TO: Mercedes-Benz Dealer Principals, General	FROM: Gregory Gunther, Department Manager,	
Managers, Sales Managers, Service Managers, Parts	Vehicle Compliance and Analysis, Engineering	
Managers	Services	
RE: Recall Campaign Launch Notification		
Rear Seatbelt Latch Plate	date: May 4, 2018	
MY16-17 X253 (GLC-Class)

Recall Campaign Bulletin

Campaign No. 2018030012, May 2018 Revision B

SUBJECT: Model X253 Model Year 2016-2018 Seatbelt Latch Plate

Figure 6

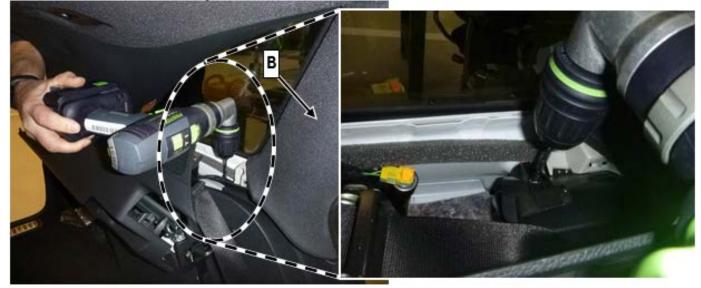
- 5. On C-pillar (B, figure 6) Drill hole (Ø 4.5 mm) at bottom of trim. (Use new pointed drill bit.)
- i measure and mark the location to be drilled (1, figure 7) approx. 23 mm at center.

I Remove seat belt from drilling area.

Figure 10

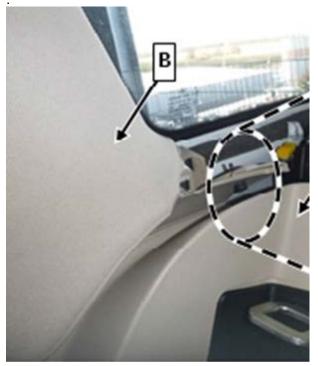
8. Drag the C-pillar trim **(B, figure 10)** to the lowest possible position. Wear gloves
